Before the
Federal Communications Commission
Washington, D.C. 20554

MM Docket No. 99-25

Creation of a Low
Power Radio Service

PETITION FOR RECONSIDERATION

Figure 1

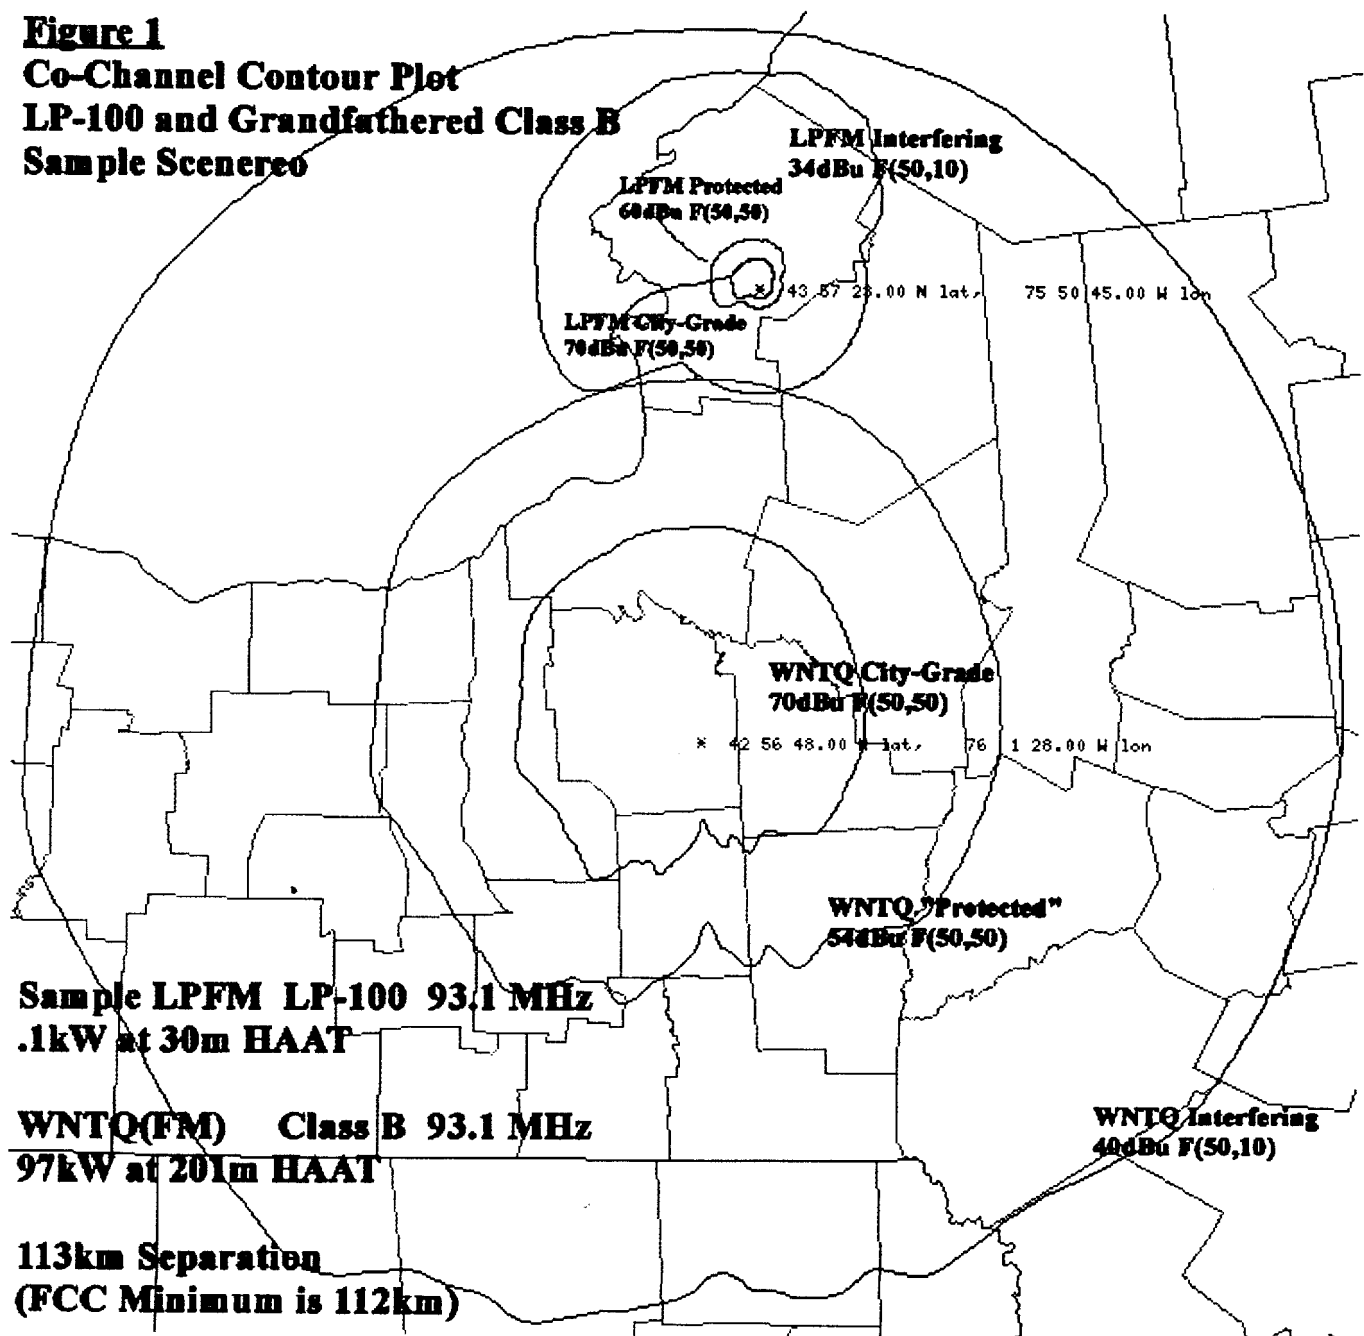
Because the Commission does not recognize commercial grandfathered facilities in the LPFM rules, the minimum distance separation required for a co-channel 100-watt LPFM station to any Class B station is 112km, or about 70 miles.⁶ For WNTQ, I know this is inadequate because it can be easily heard 70 miles to the North. The signal will also scan on many car radios at this distance. I picked a site 113km or 71 miles away and performed a contour analysis.⁷ See Figure 1.

Using standard Commission contour methodology, In Figure 1, the 40dBu F(50,10) interfering contour of WNTQ (marked in red) should not cross the 60dBu F(50,50) protected contour of the LP-100 station (marked in blue)⁸. Note that the interfering contour of WNTQ completely passes over into the service area of the LP-100’s blue contour by over 40 miles. The LPFM station will be trampled by WNTQ. Severe interference will result.

Likewise, the 34dBu F(50,10) interfering contour of the LP-100 station (marked in red) should not cross the 54dBu F(50,50) “protected”⁹ contour of WNTQ (marked in blue). Yes, there will be interference in the outer fringe coverage of WNTQ, but very limited in scope compared to the drastic effect WNTQ will have on the LPFM station.
